**TOWN OF HERNDON, VIRGINIA
ARCHITECTURAL REVIEW BOARD WORK SESSION AGENDA
AUGUST 3, 2022
HERNDON MUNICIPAL CENTER
LARGE CONFERENCE ROOM, 2nd Floor
777 LYNN STREET
7:30 P.M.**

Title: ARB #22-018; New signage and awning alteration; 1142 Elden Street, 1100 Herndon Parkway

Subject: Pre-application ARB Discussion Item, DPA #21-01, 555 Herndon Parkway

Subject: Pre-application ARB Discussion Item, DP #21-01, 555 Herndon Parkway

Sign Details

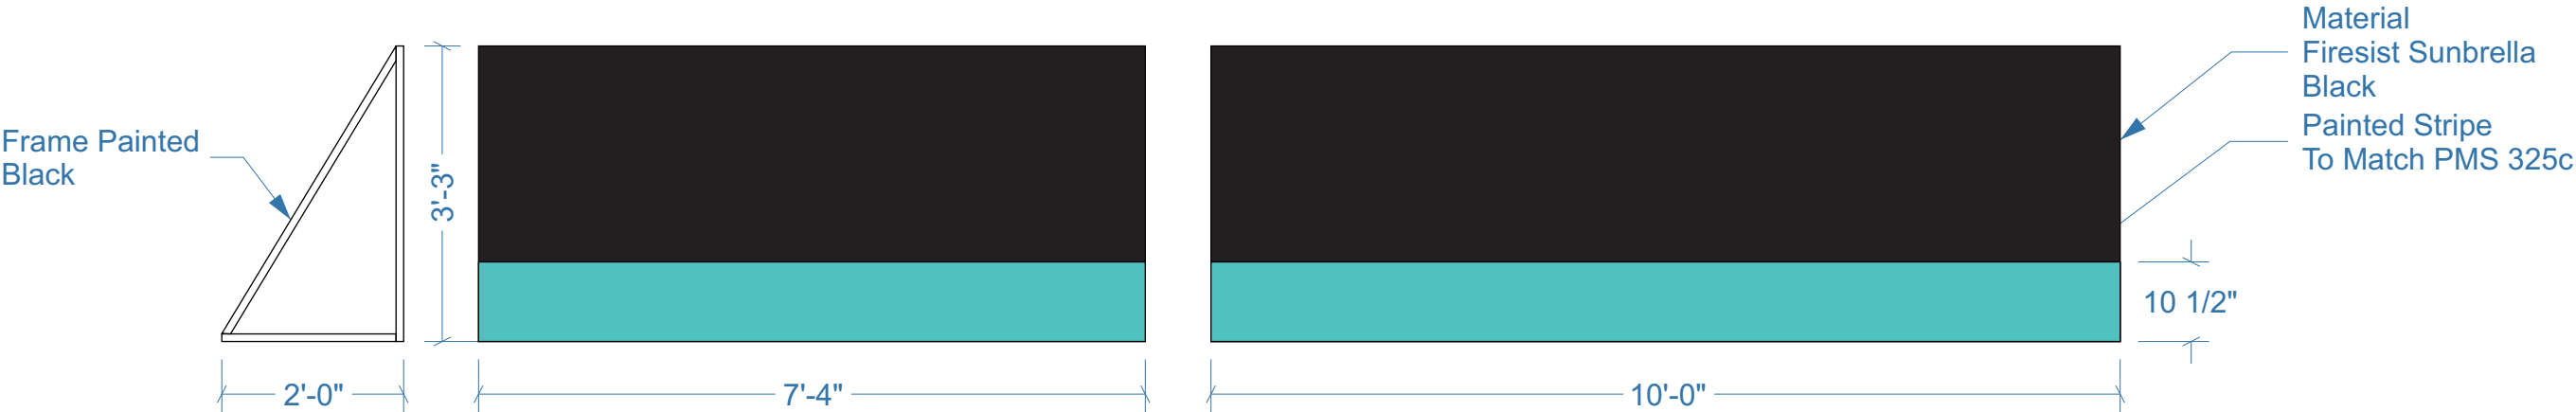
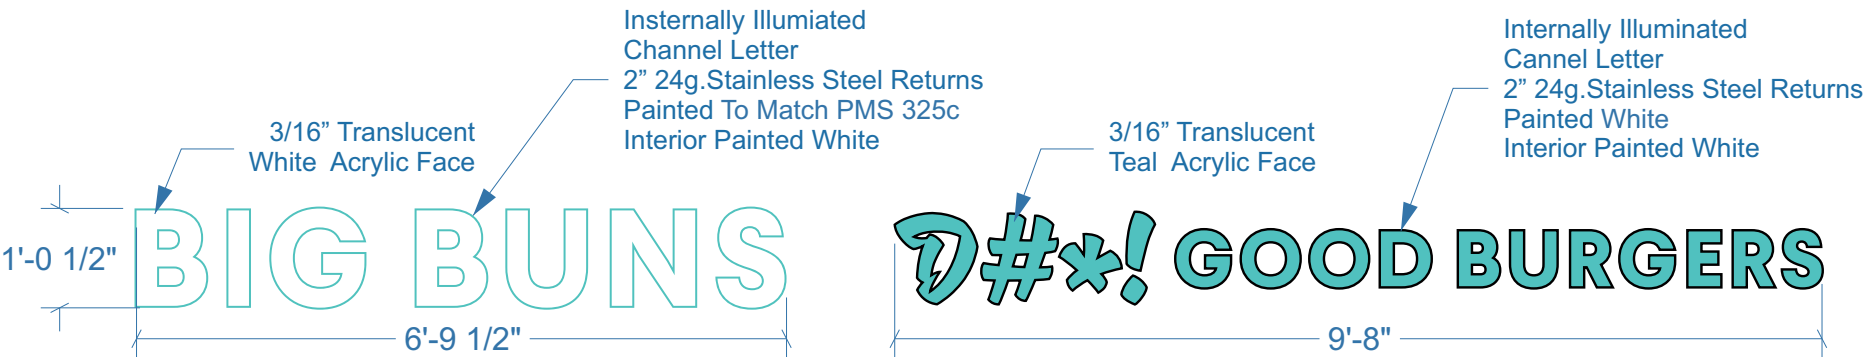
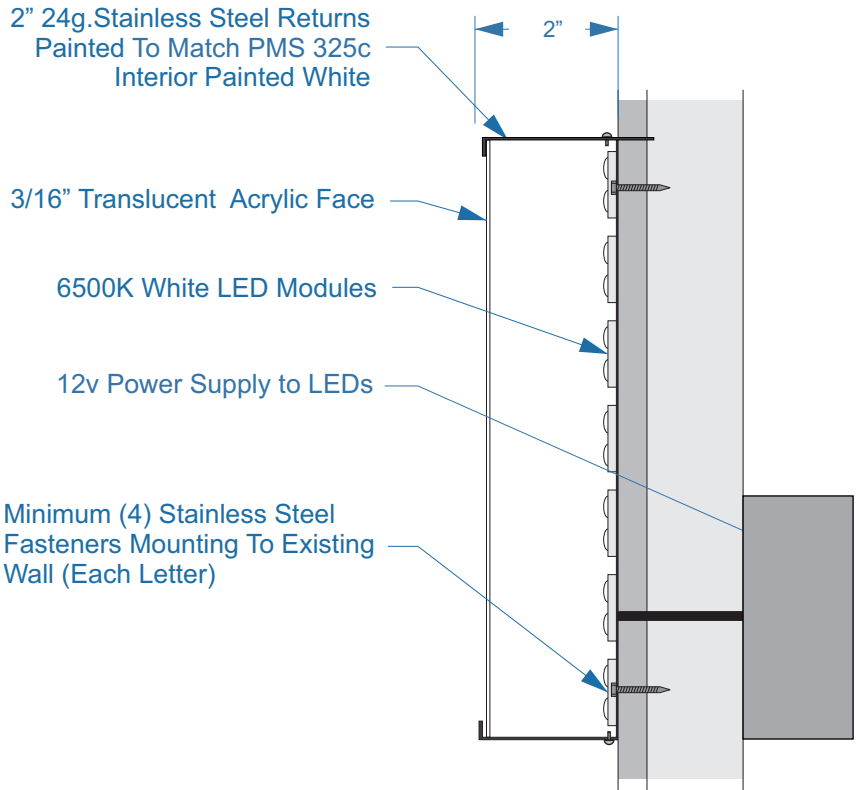
- a. The proposed wall sign in its design and construction is suitable for a good suburban community and promotes the use and improvement of the surrounding buildings.
 - b. The proposed wall sign clearly and legibly represents the intended business
 - c. The proposed wall sign is constructed in a way so as to remain in good condition and withstand normal weather and climate conditions without deteriorating.
3. The existing awnings appear worn and damaged. Staff believes that the proposed repainting of the frame and recovering with new fabric are appropriate for the building and area.

Approves ARB #22-018, for signage and re-covering existing awnings on a building at 1142 Elden Street, Herndon, Virginia, on property located at 1100 Herndon Parkway, Herndon, VA in substantial conformance with the design shown in the case materials reviewed by the ARB.

NORTH ELEVATION

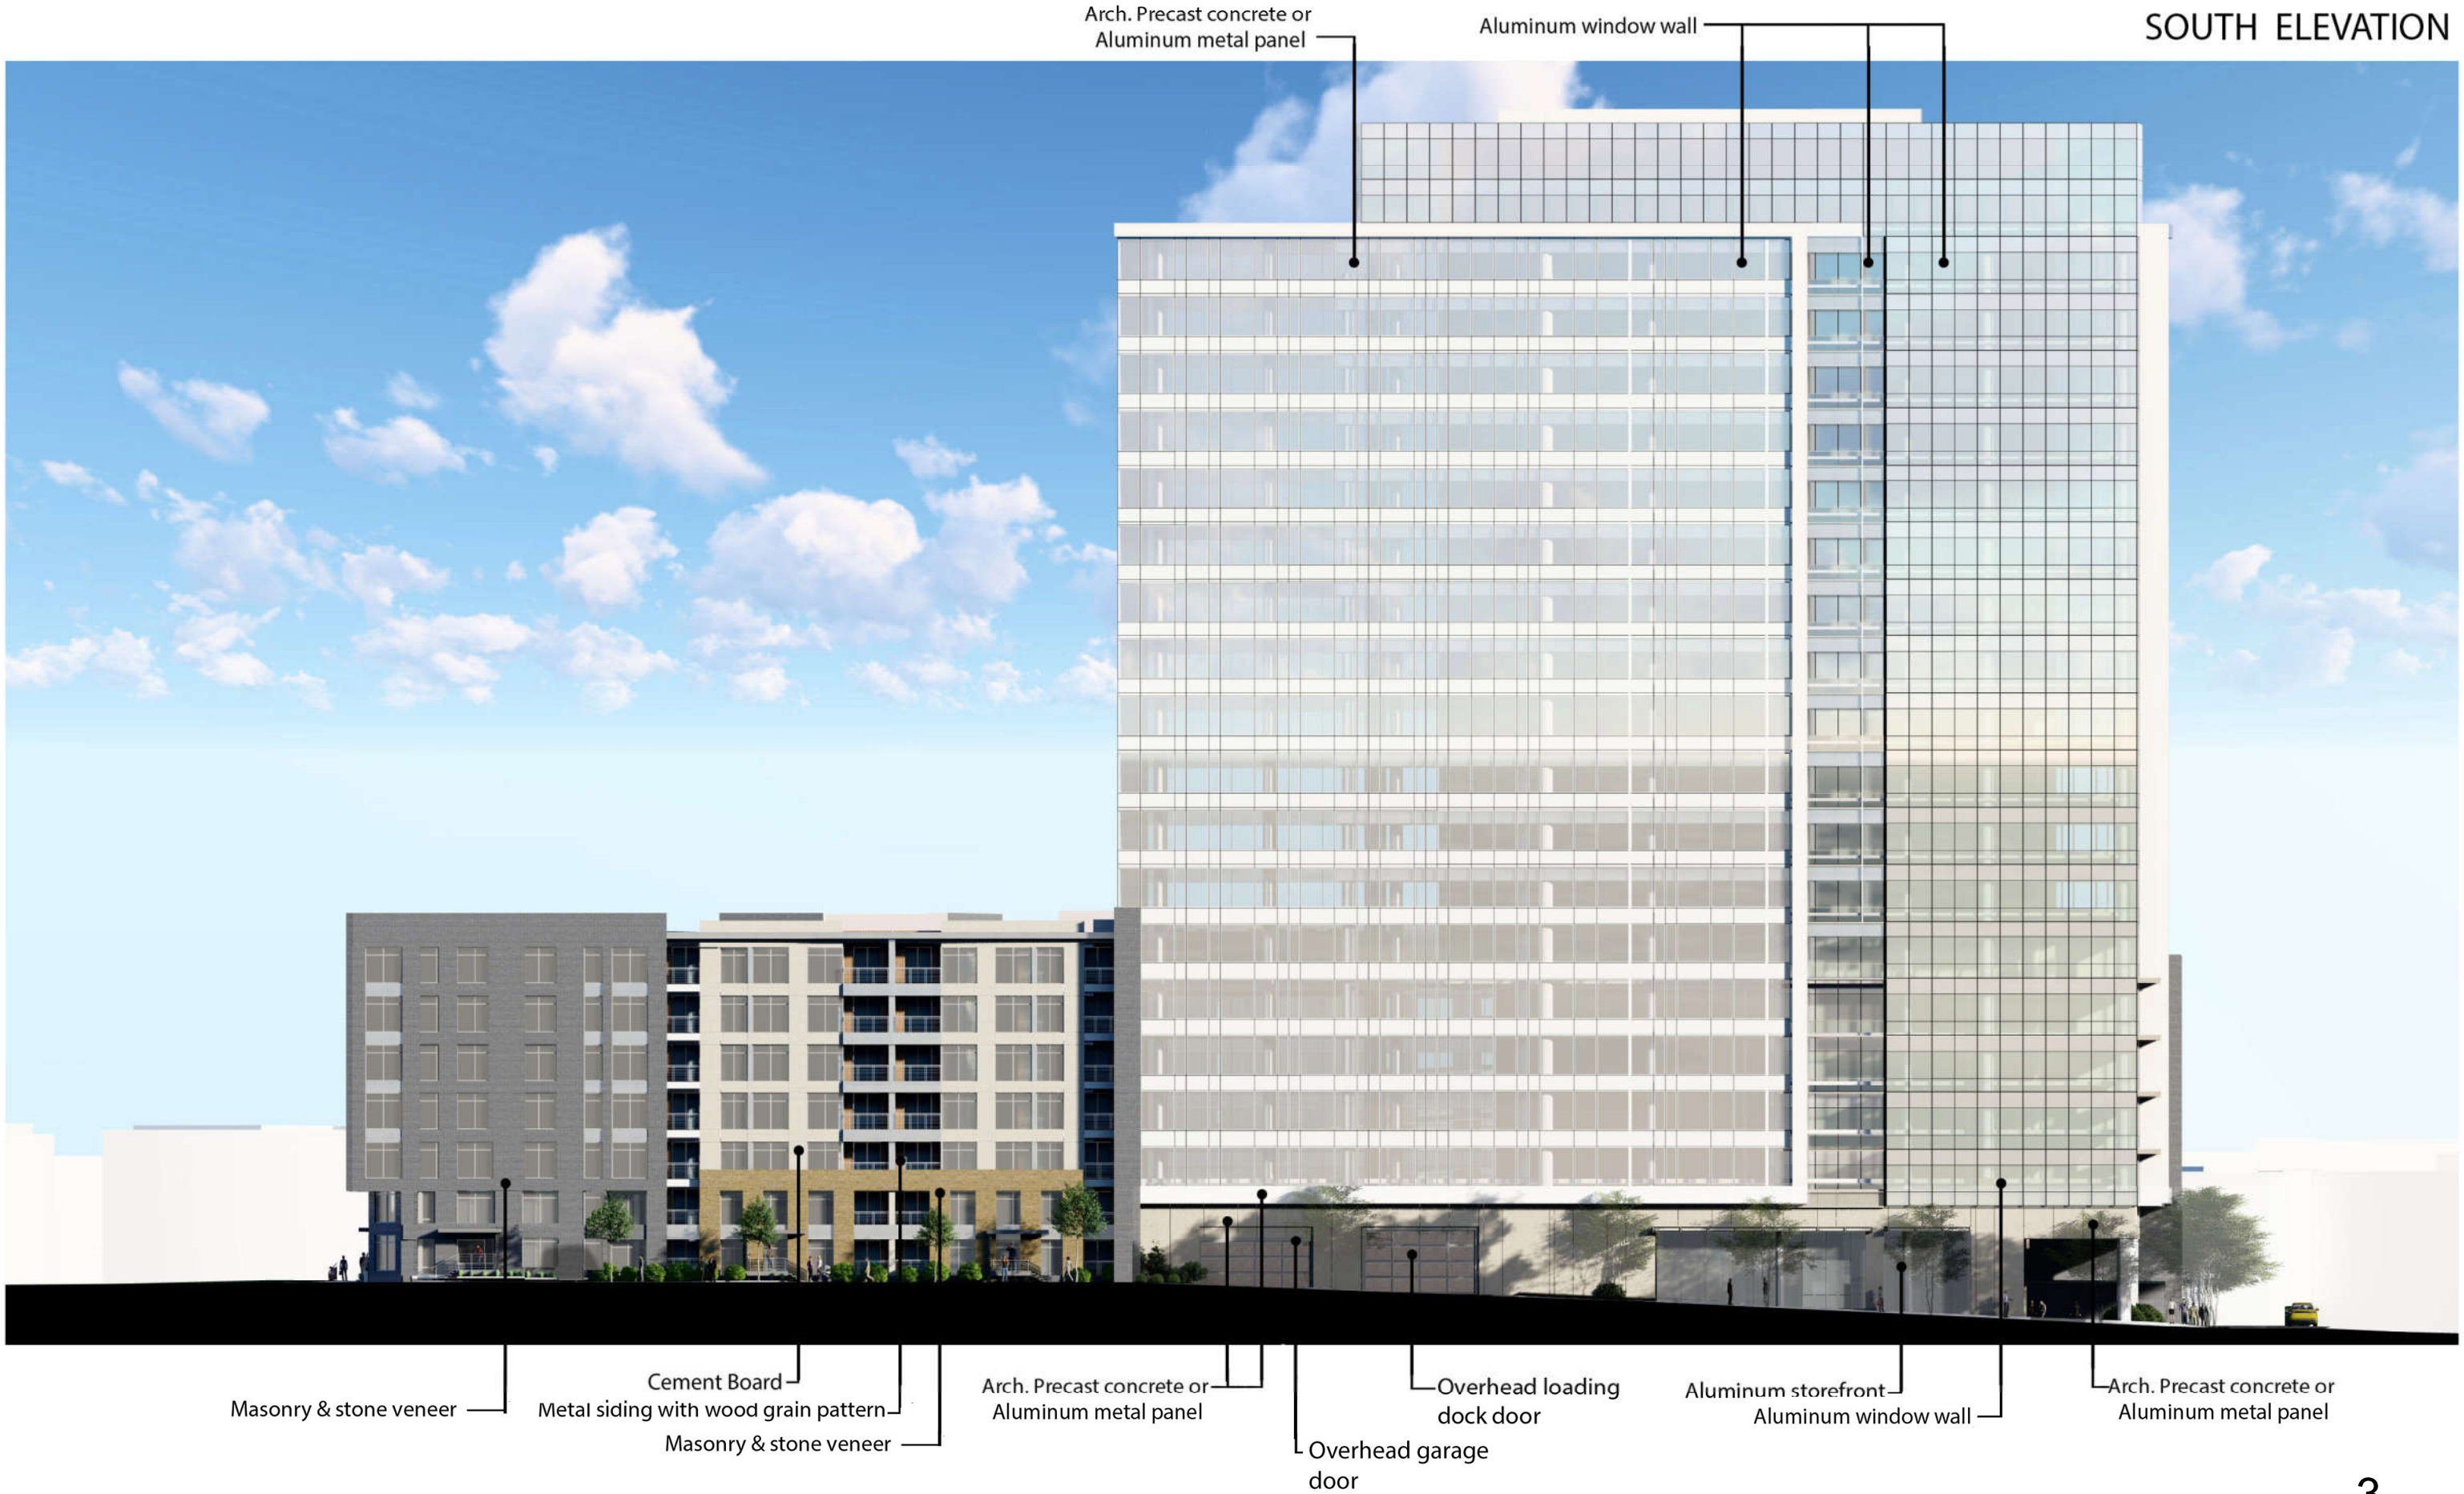
The residential structure construction is stick over concrete podium. This construction technique poses a challenge as the upper floors often appear visually disconnected from the podium. The former and current elevations are not "articulated vertically to resemble an ensemble of smaller buildings and horizontally into a base, middle and top" (page 32 of the Guidelines). Stronger vertical elements extending from the ground to the top, or just below the top, of the facades are needed to help accomplish this vertical articulation. Alignment, material, and depth are all important elements of successful articulation.

The Guidelines call for large elevations to be articulated to appear as a group of smaller buildings. In addition to stronger vertical elements, more articulated building crowns or pediments are needed to distinguish sections of the building from one another. In addition to this, the applicants may want to consider visually dividing the façade to resemble fewer larger separate buildings instead of many narrow separate buildings. Staff

The north façade, along Herndon Parkway, provides pedestrian access and open space between two wings of the development. These two wings are midrise structures and primarily residential, but with potential retail spaces on the ground floor of the west wing. The north elevation displays some open space and retail and is the primary pedestrian access and interaction point in the development. The open space recedes into the block with the two wings of the development on either side. The design, materials and color scheme of this façade is nearly identical to other facades (as described below) -- some variation in materials and fenestration, but uniform in most respects. The ground floor near the retail space includes cylindrical support columns under which is pedestrian interactive open space. The storefronts are described only as "aluminum storefront" and a series of canopies over the storefront windows is shown. The internal courtyard area includes landscaping and vehicle access.

The east elevations consist of five stories of residential space. The design and use of much of the first floor is unclear given the size of the provided drawings. The ARB may wish to ask for clarification regarding the uses of this area. The façade is simple, modern, and stark using blank surfaces and regular flat window fenestration. The façade plain is broken up using alternating materials and a series of recesses and protruding blocks of windows and occasional recessed residential balconies. Façade materials include cement board, architectural precast concrete, aluminum metal panel, metal siding with

Primarily residential, the west elevation does include potential retail space at the far north corner of the ground floor. This portion is nearest to the Herndon Parkway and the pedestrian open space. The potential retail space includes aluminum storefronts and canopies. The remainder of the ground floor appears to feature a loading dock, and some pedestrian access and the vehicle access to the courtyard. Like the other residential portions of the development, the façade is primarily flat with regular window openings, broken by occasional rows of recessed residential balconies and protruding portions of the façade. The color scheme is gray to white. Materials on this façade also include composite paneling, cement board, metal siding with wood grain pattern, masonry and stone veneer, and aluminum metal panel.
